The Outer Ring Road Diversion Channel in the Comprehensive Flood Management Plan for the Chao Phraya River Basin in the Kingdom of Thailand

付属資料 7 JICA からの質問状 RID からの回答書 JICA からの提言

Subject: Questions about nine planned flood management projects in Chao Phraya river

Reference: Recommendation to the nine planned flood management projects in Chao

Fig 2 Effect of Diversion Channel and Ayutthaya Bypass

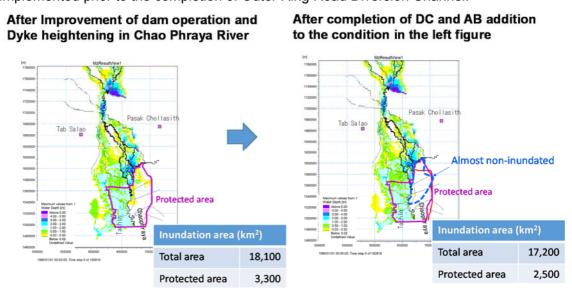
2) Project effect of Outer Ring Road Diversion Channel and Ayutthaya Bypass RID should implement the Outer Ring Road Diversion Channel after completion of "Improvement of dam operation" and "Dyke heightening in weak part of downstream of Chao Phraya River" as described in the above paragraph. By completing Outer Ring Road Diversion Channel together with Ayutthaya Bypass, the inundation area will be greatly reduced. These effect is shown in Fig 2. However Ayutthaya Bypass should not be implemented prior to the completion of Outer Ring Road Diversion Channel.

Fig 3 Comparison of water level for 2011 Flood with and without Ayutthaya Bypass

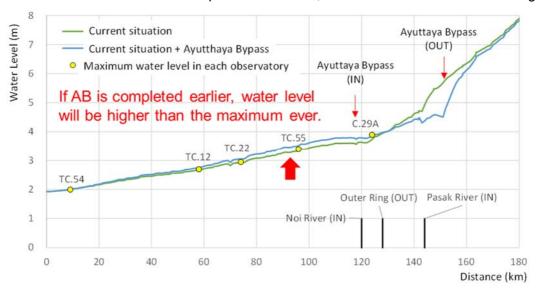
- If 2011-scale floods occur, as shown in Fig 3, flood damage will decrease around the diversion point. However, the water level in Chao Phraya River will rise caused by the increased discharge around downstream of the bypass. Therefore, it is concerned that condition will be more dangerous, comparing with the 2011 flood. The project, which will make downstream area more dangerous against flood, should not be implemented prior to the completion of Outer Ring Road Diversion Channel. The defect of the government is going to be held liable for.

- RID explained that since Ayutthaya Bypass will be installed a gate, it would not create this problem. Because the gate will be closed during large scale flood. However, it is unlikely that they can close the gate in the situation that the flood is occurring in the area of upper stream of Ayutthaya Bypass due to relation with the local residents. It should be considered based on practical situation, and it should not be unrealistic logic.

Fig 4 Comparison of inundation area

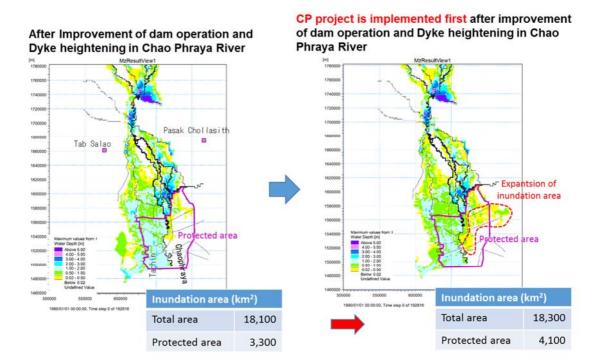
If 2011-scale floods is occurred, flood damages will decrease in some areas by the channel. However, floods will occur around the Pasak River, and the Pasak River and its downstream basin is assumed to be suffered by serious flood damages more than without the channel. Therefore, the project should not be implemented first. The defect of the government is going to be held liable for.

Flood damage will be larger

Fig 7 Transition of inundation area in case 2011 flood

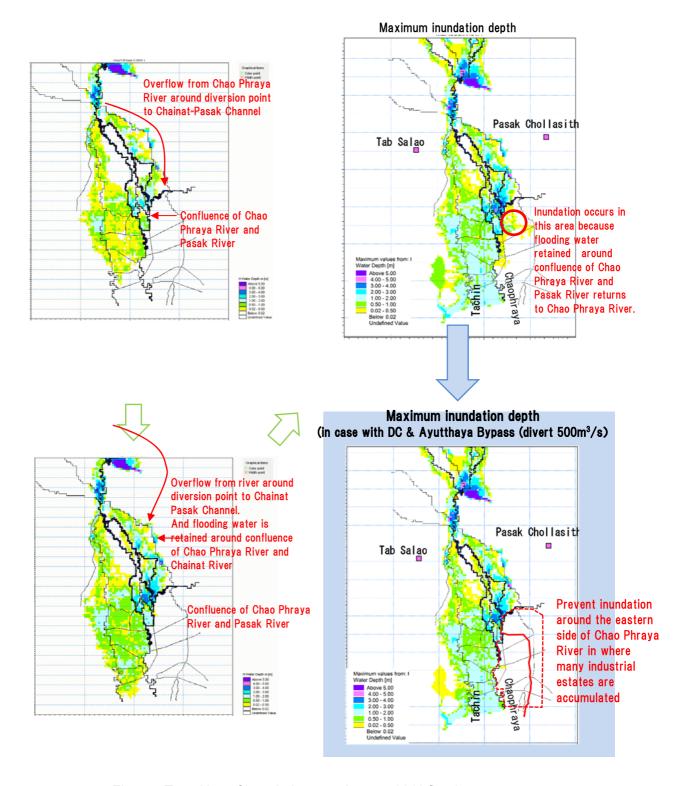
- (2) Effect of Outer Ring Road Diversion Channel and Ayutthaya Bypass (Transition of inundation area in case 2011 flood)
- Overflow occurs from the Chao Phraya River around the diversion point to the Chainat-Pasak Channel as following figure indicates.

- The flooding stream is stored near Ayutthaya for a while. After that, the flooding stream returns into the river channel and increase discharge again. This is a process of flood damage in the vicinity of Outer Ring Road Diversion Channel.

→Even after improving the river channel, the overflow from the upstream will not go away. The flooding stream returns to the river channel from the confluence of Chao Phraya River and Pasak River. Inundation around the left (eastern) side of Chao Phraya River will be eliminated, if DC (diversion discharge 500m³/s) and Ayutthaya Bypass are completed.
